Chevron Products Company
6001 Bollinger Canyon Road
San Ramon, CA 94583
Tel 925-842-5054
Nick.Economides@chevron.com

September 6, 2017

Re: California LCFS Revisions–Comments on ARB Pre-Rulemaking Package from August 7, 2017 Workshop

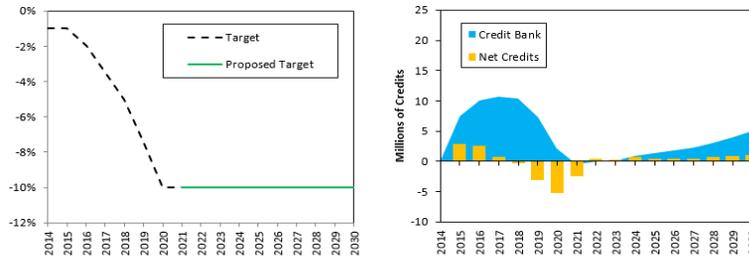
The process and the flowchart lacks timelines for each phase of the work. The reader may have difficulty getting the "big picture" and understanding when all this is supposed to come together. It would be useful if staff added timelines to the flowchart.

- In the flowchart, the "Public Comment" box needs to be connected to: "CA-BAM" and "Preliminary Evaluation" boxes by arrows, as explained in The Concept Paper Appendix A text.

- Concept Paper Page A-5, first sentence under Phase 4 heading: “phases 1-4” needed to be revised to “phases 1-3”
- “Compliance Calculator” box of the flowchart in Phase 4 of the process: the title for this box seems incorrect, as Compliance Calculator is developed in Phase 3 of the process. We suggest replacing it with a more descriptive tile like: “Scenario Analysis.”
- Similar to the bullet point above, the “Results” box description could be changed to a more descriptive title like “Target Setting.”

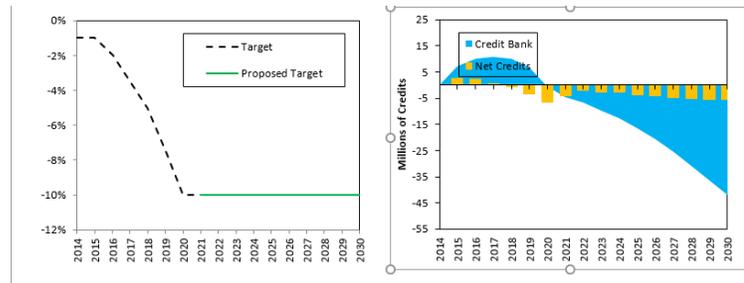
- If CI mandate held flat at 10% post-2020, the model predicts a slightly **negative credit bank** in the early 2020s even assuming a statewide 30% decrease in gasoline demand.

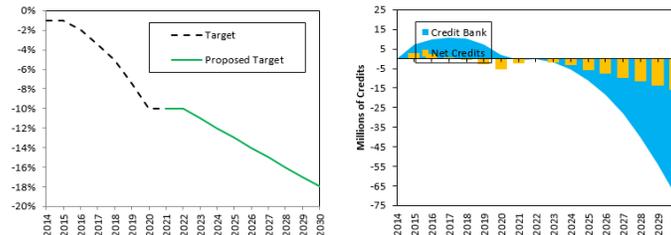
- If gasoline demand is assumed flat, with the 10% CI target held flat through 2030, the cumulative credit bank in 2030 is **negative 40 million MT**
